1 **Response to Reviewers Comments:**

2 Title: Characterization of the Particle Emission from Ships Operating at Sea Using Unmanned
3 Aerial Vehicles

4 Authors: Tommaso F. Villa, Reece Brown, E. Rohan Jayaratne, L. Felipe Gonzalez, Lidia
5 Morawska, Zoran D. Ristovski

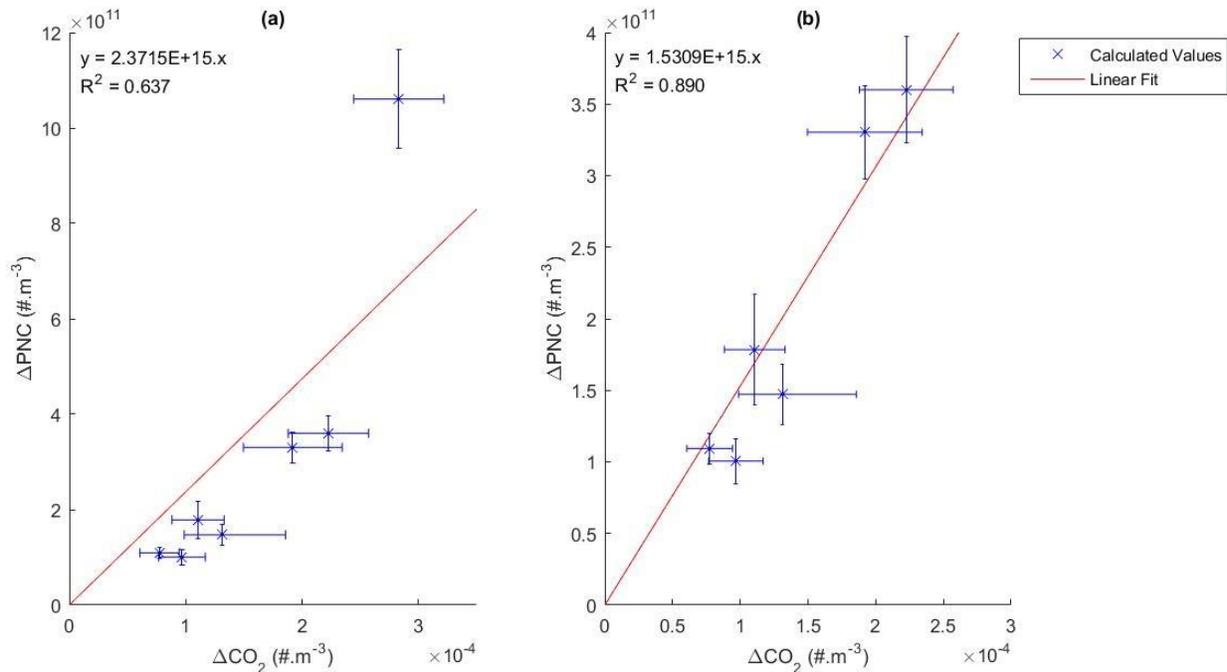
82 **Comment 8:** Table 2 vs. Fig. 5: There seems to be an inconsistency. The slope from Fig. 5 can be
 83 converted to an EF by multiplying by 3.2 kg CO₂/kg-fuel. This yields 6.4e15 particles/kg-fuel.
 84 But, the average from Table 2 is only 2.6e15 particles/kg-fuel. These should be closer. The
 85 difference may be because the authors have not fixed their intercept to zero. This should be
 86 looked at by the authors. Also, in Fig. 5 the x-axis should start from zero.

87 **Answer 8:** The authors have considered the Reviewer's comment. In the new methodology the
 88 final EF_{PN} is calculated using the slope of the line with the intercept fixed at zero as
 89 recommended here. The axis has also been updated to start from origin.
